# Hove Gardens, Hove Section 73 - Pre-App Report - NMA

July 2021  
CJCT  
Section 73 Report  
Planning Ref: BH2020/00917  
Rev 04

## Brief & Summary of Changes

## 2.4 North Elevation - Proposed

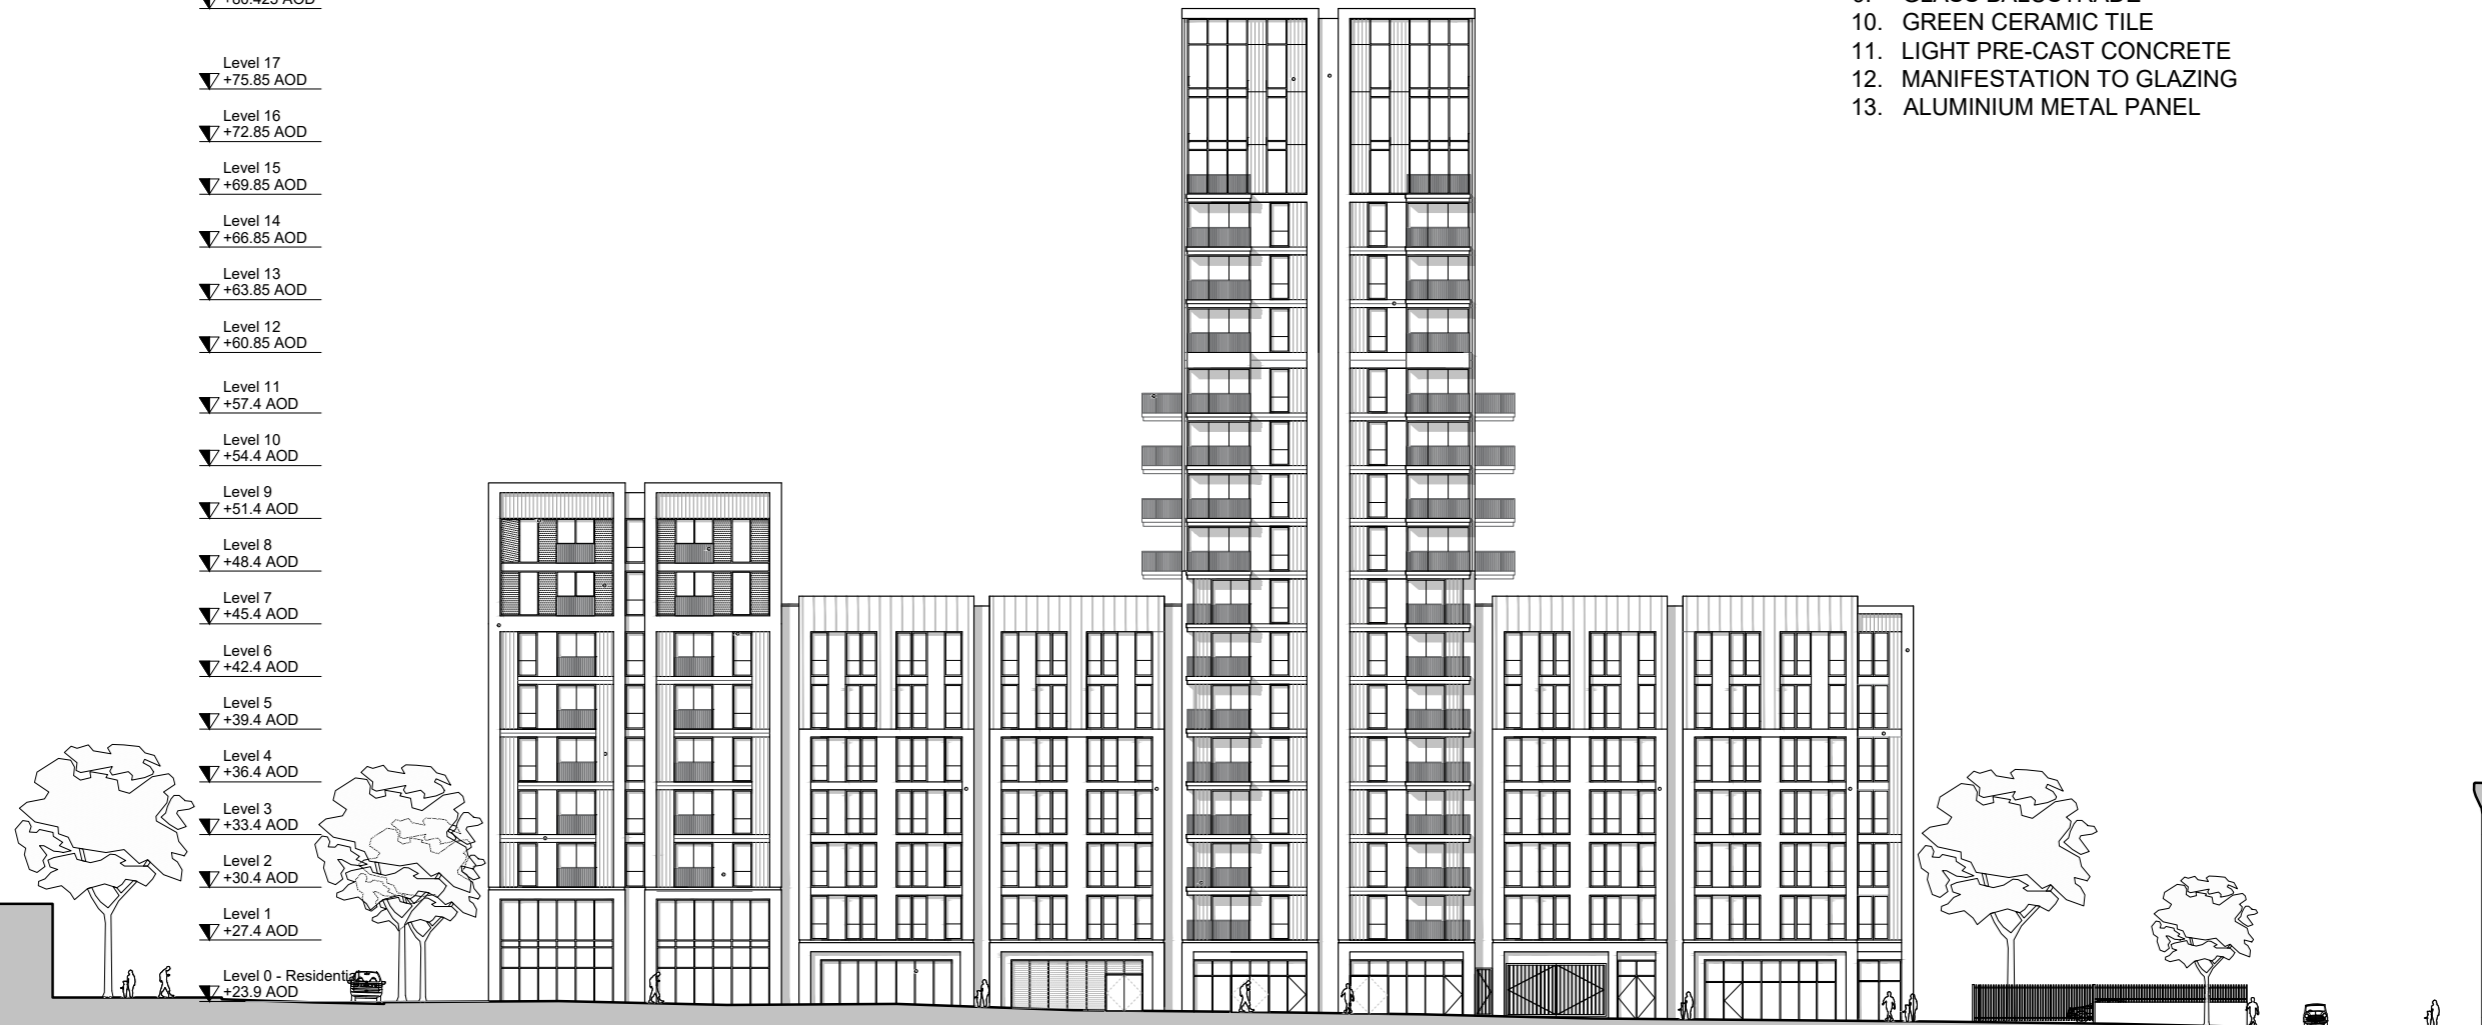
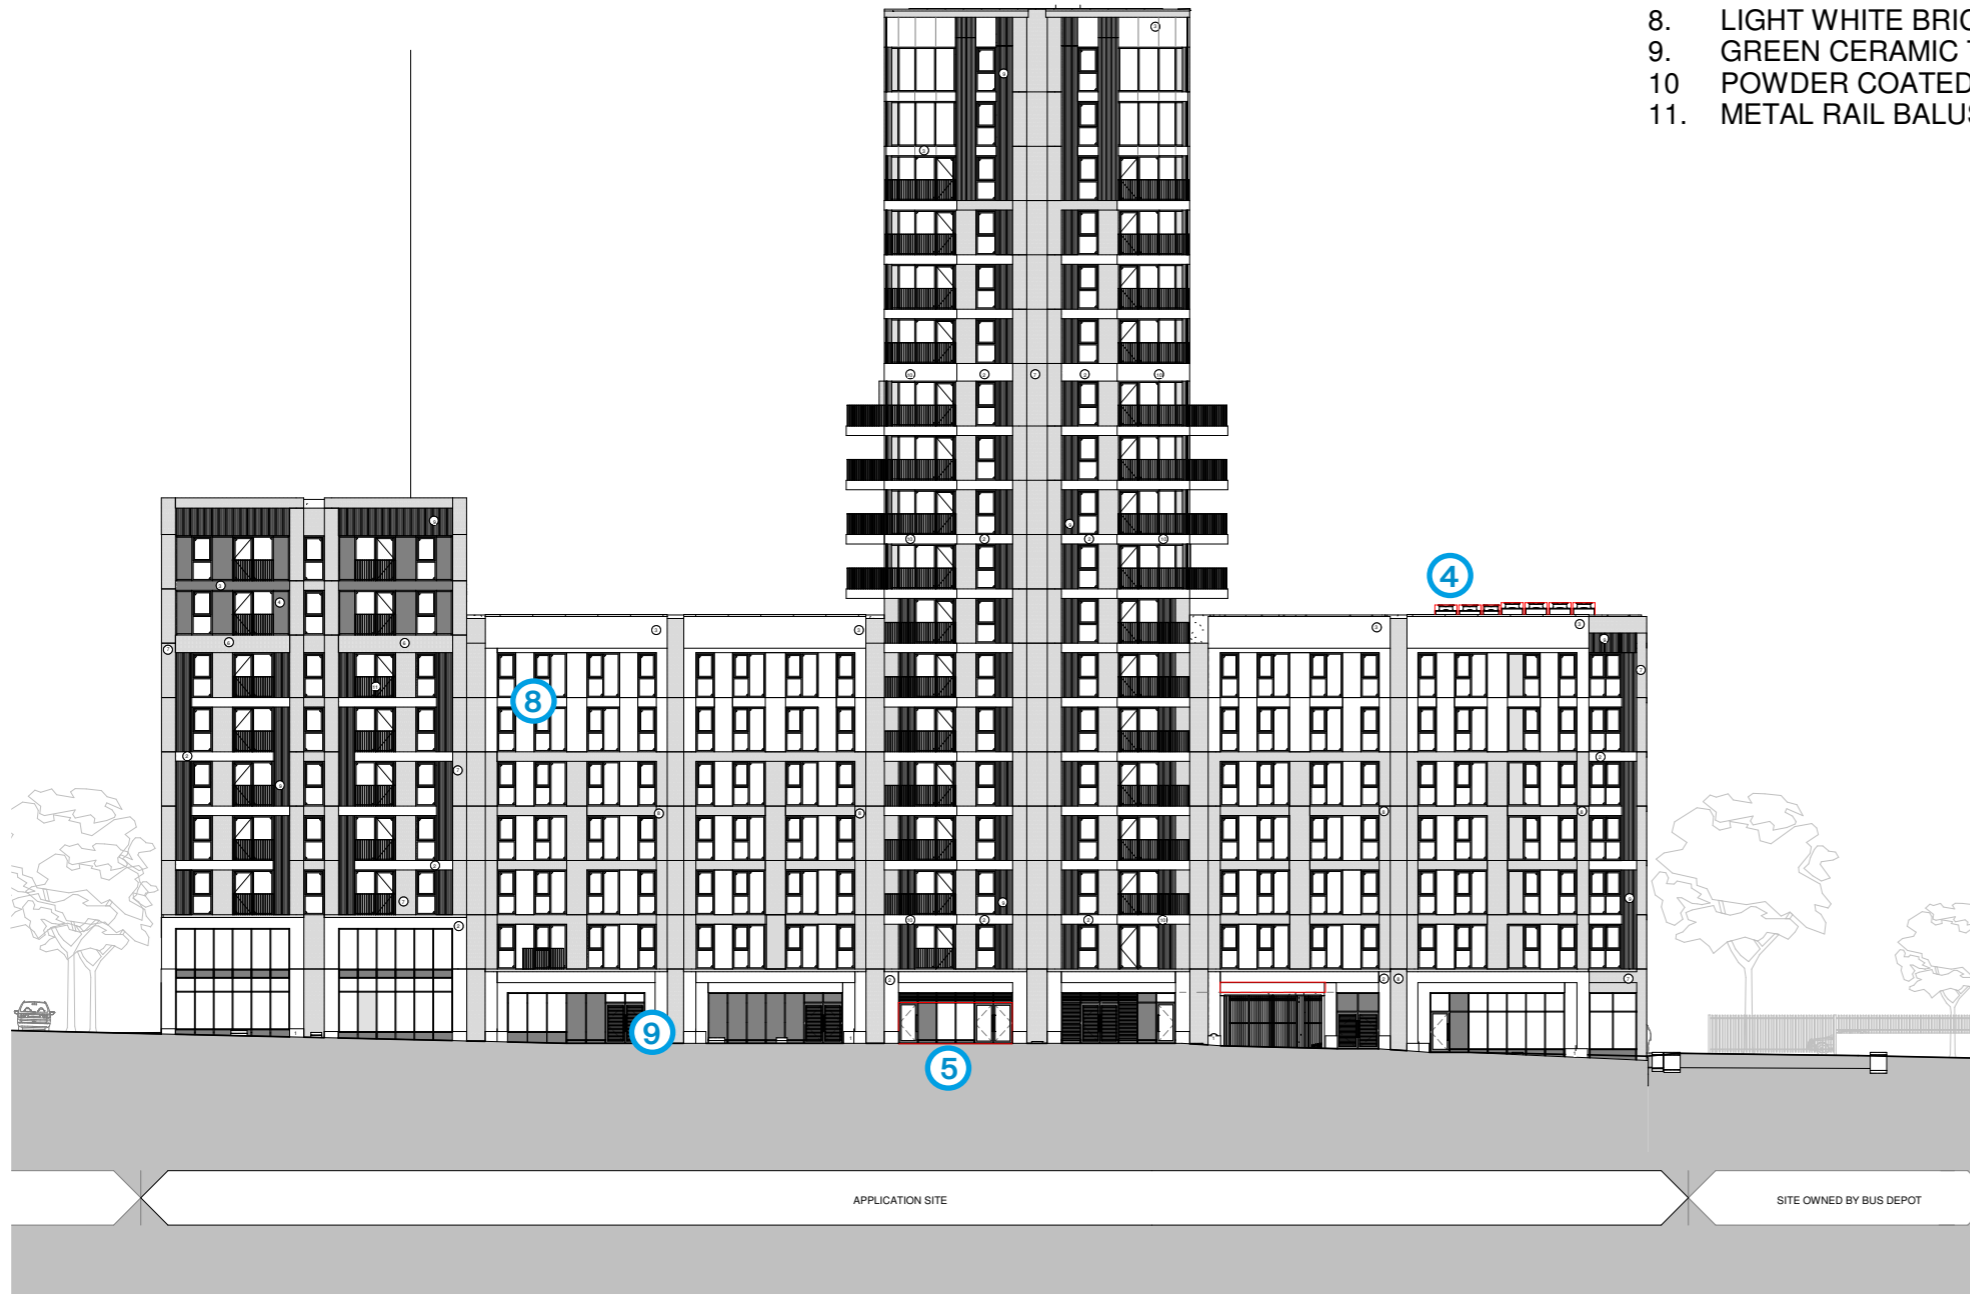
- ① Removal of slab voids to deck access
- ② Columns added to support weight of projecting deck
- ③ Balustrading updated to vertical railing
- ④ ASHP's located on level 7 roof
- ⑤ Updated ground floor layout to improve active frontage and maximise commercial offering. Dedicated Commercial Refuse Storage
- ⑥ Updated basement layout following full MEP and structural optimisation - Improved cycle storage
- ⑦ Updated landscape proposals to accommodate basement ventilation
- ⑧ Anodized Aluminium Panels
- ⑨ Dark Stone at Base
- ⑩ Omitted juliet balcony
- ⑪ Aluminium fascia at balconies
- ⑫ Solid Metal Panel to be welded to the backside of the metal railing balustrade
